# UNITED STATES PATENT AND TRADEMARK OFFICE

APPLICATION NO.	FILING DATE	FIRST NAMED INVENTOR	ATTORNEY DOCKET NO.	CONFIRMATION NO.
10/764,139	01/22/2004	Paul P. Duron	4072	6079

<b>Office Action Summary</b>	<b>Application No.</b> 10/764,139	<b>Applicant(s)</b> DURON, PAUL P.	
	<b>Examiner</b> Samuel E. Belt	<b>Art Unit</b> 3746

## **DETAILED ACTION**

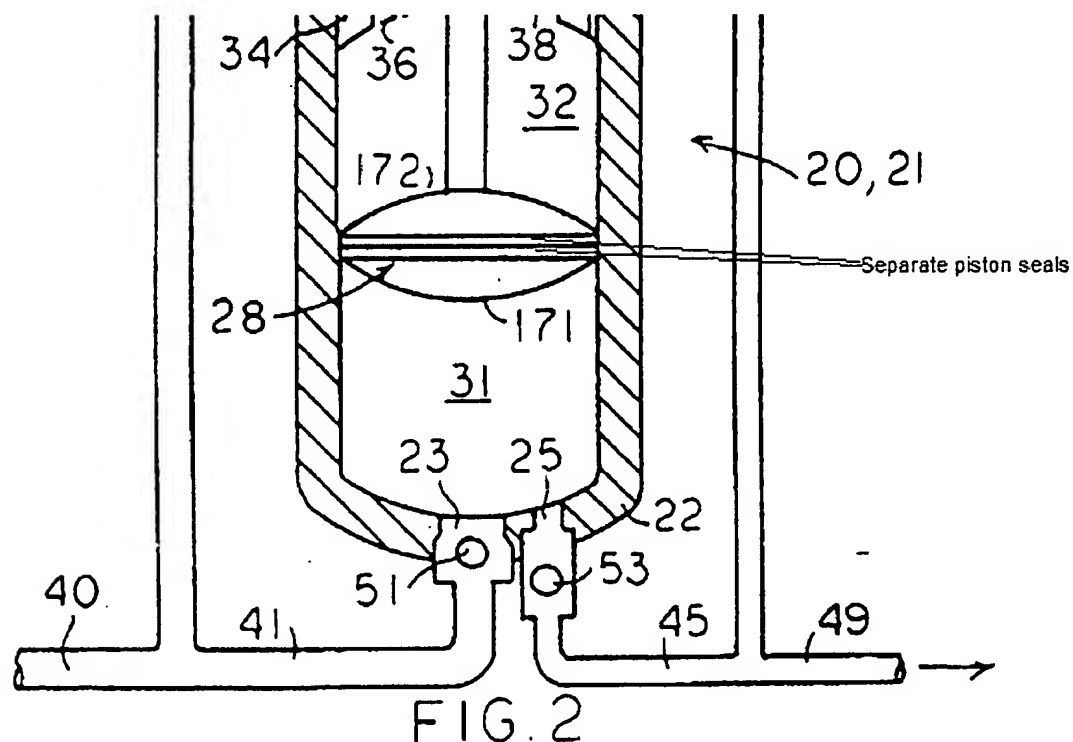
Gram discloses a double-acting, reciprocating piston, high pressure, cryogenic pump comprising; a cylinder; a piston rod (Figure 2, item 30); a pair of spaced apart piston heads (Figure 2, items 171, 172) on said piston rod; a venting passageway for venting blow-by vapors or fluids between the piston heads (column 9, lines 26 +, see note); whereby blow-by vapors or fluids are reclaimed and do not interfere with normal operation of said cryogenic pump; each of the piston heads having a separate seal

(**Notes:** The examiner is interpreting both piston faces 171 & 172 as being separate "piston heads" which are both mounted onto the same piston rod and each has its own separate seals, see figure below.

FIG. 1

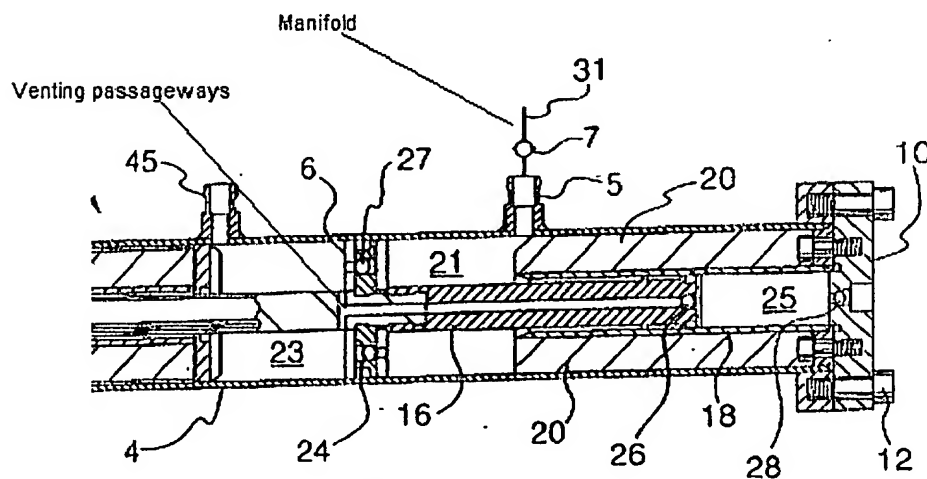
which is substantially analogous to the claimed invention. The Gram and Schuck device differs from the claimed invention in that there is no explicit teaching of the piston rod having a through passageway for venting the vapor or fluid. Gram et al. teach a pump having a piston rod with a through passage (see paragraph [0075]).

In regards to claims 6-9 please refer to figure below for further clarification of the Gram et al. reference.
